# MASH TL-3 Testing and Evaluation of Large Signs Slipbase Support on Slope

**Technical Representative: D. Sheppard (FL)**

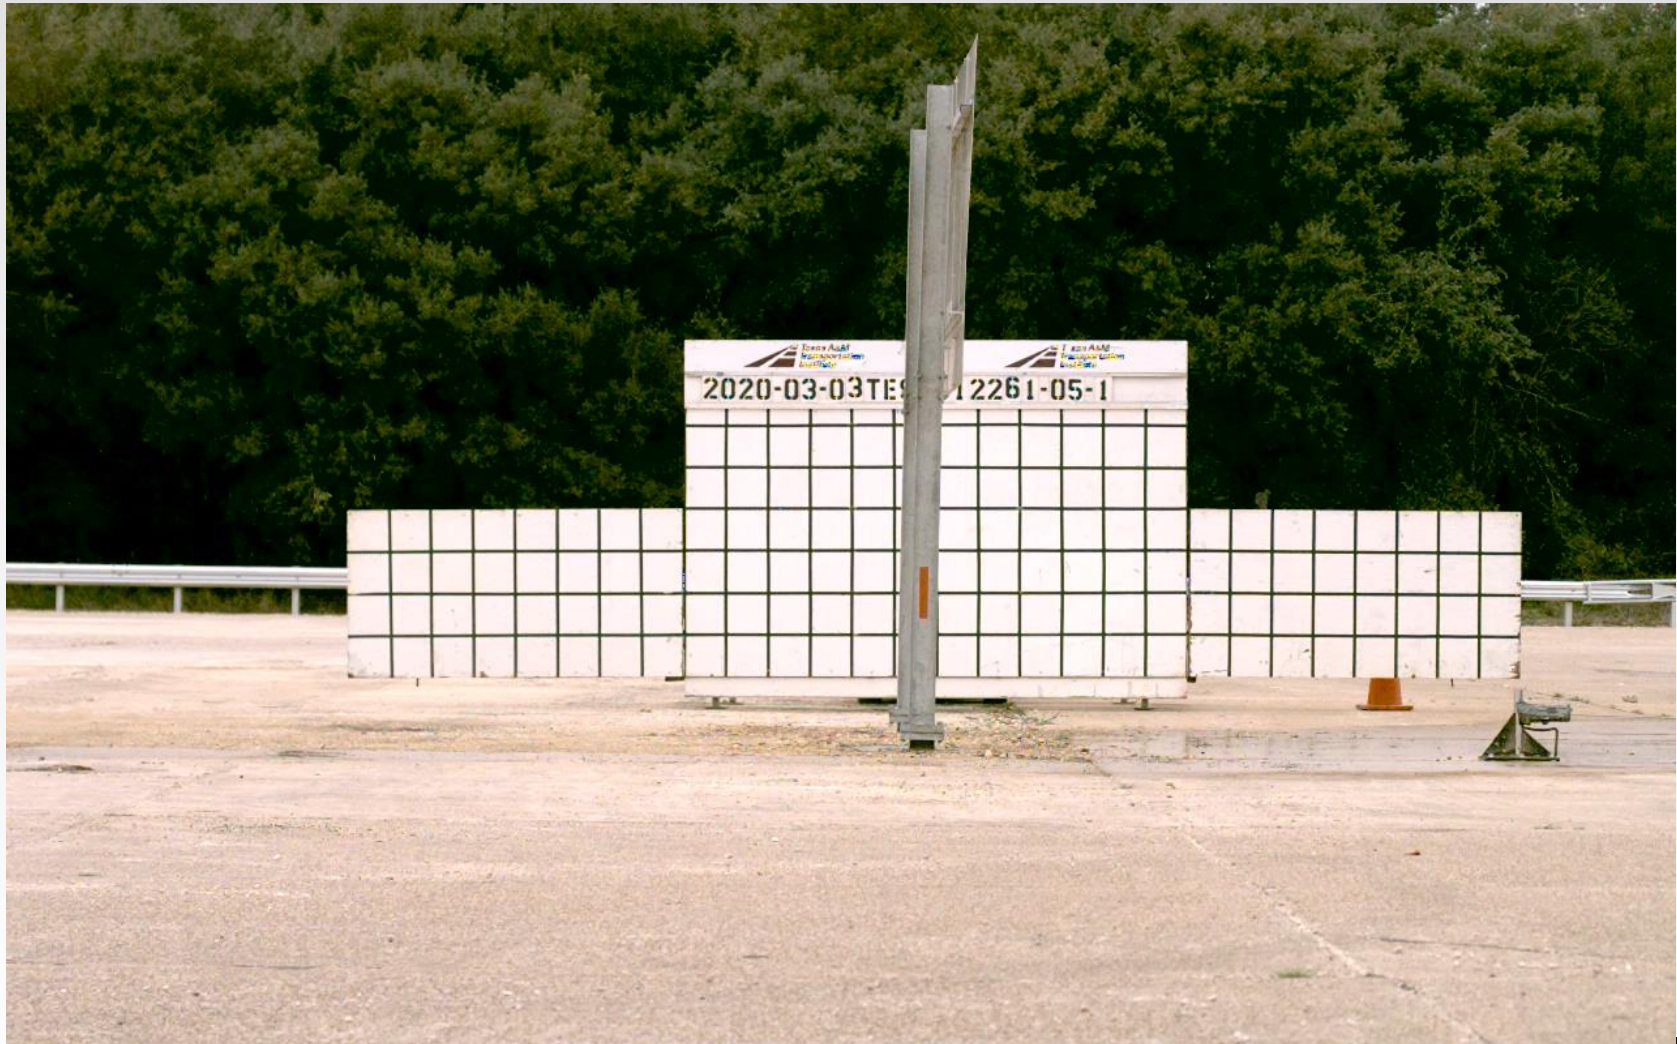
Post Size	Width	Hole Size	Number of Holes	Thickness	Area	Fu (Kips)	Depth (ft)	Total Depth (ft)	Fuse Plate Capacity (Kip*ft)	ASD Factor	Final Fuse Plate Capacity (kip*ft)
TxDOT	W6x12	4.0	0.750	4	0.250	0.250	58.0	0.500	0.521	7.552	2.00	<b>3.776</b>
Florida	W6x12	4.00	0.813	4	0.375	0.281	58.0	0.50	0.531	8.666	2.00	<b>4.333</b>

Post Size	Width	Hole Size	Number of Holes	Thickness	Area	Fu (Kips)	Depth (ft)	Total Depth (ft)	Hinge Plate Capacity (Kip*ft)	ASD Factor	Hinge Plate Capacity (kip*ft)
TxDOT	W6x12	4.0	0.750	4	0.250	0.250	58.0	0.500	0.521	7.552	2.00	<b>3.776</b>
Florida	W6x12	4.00	0.00	0	0.25	1.00	58.0	0.500	0.521	30.208	2.000	<b>15.104</b>

It was found that for the same size post (W6X12), hinge/fuse plate capacity for FDOT is high compared to the one used by TxDOT. Based on visual inspection, It was also found that the stiffness of the sign panel used by TxDOT is high compared to the one used by FDOT. For comparing the plates, we used an existing study carried out by TTI for TxDOT.

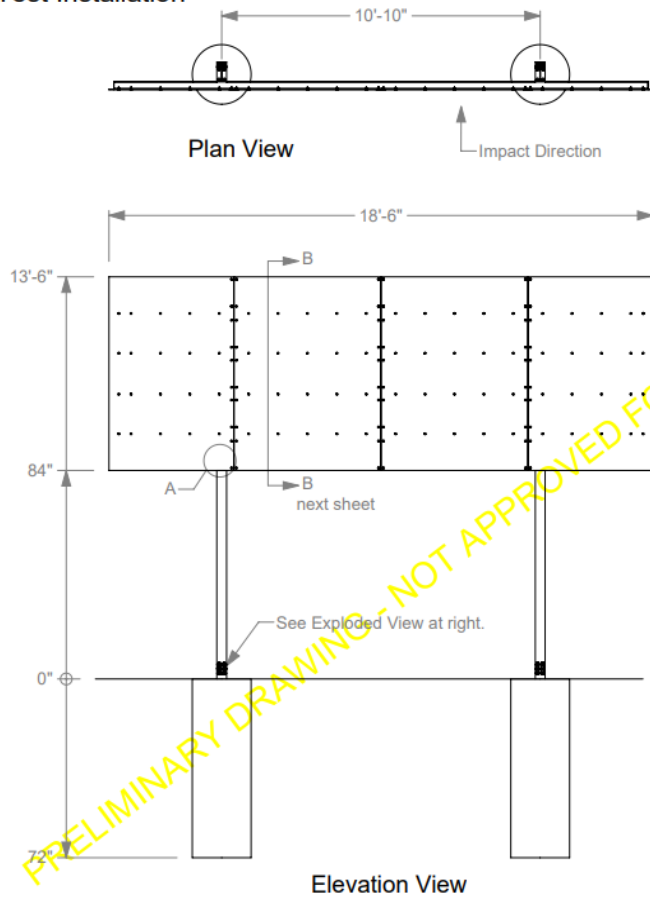
Based on our above observations we propose the following options:

- Reduce the thickness of the fuse plate based on the TxDOT sign supports.
- The thickness and design for the hinge plate can be kept the same or can be modified as per the TxDOT sign supports.
- Increasing the stiffness of sign by including the 3<sup>rd</sup> and 4<sup>th</sup> wind beam. As per the FDOT standards, the number of wind beams depends only on the height of the sign.
- The height of the fuse and hinge plate can also be increased as this will increase the moment arm and will help to activate the plates with less energy.
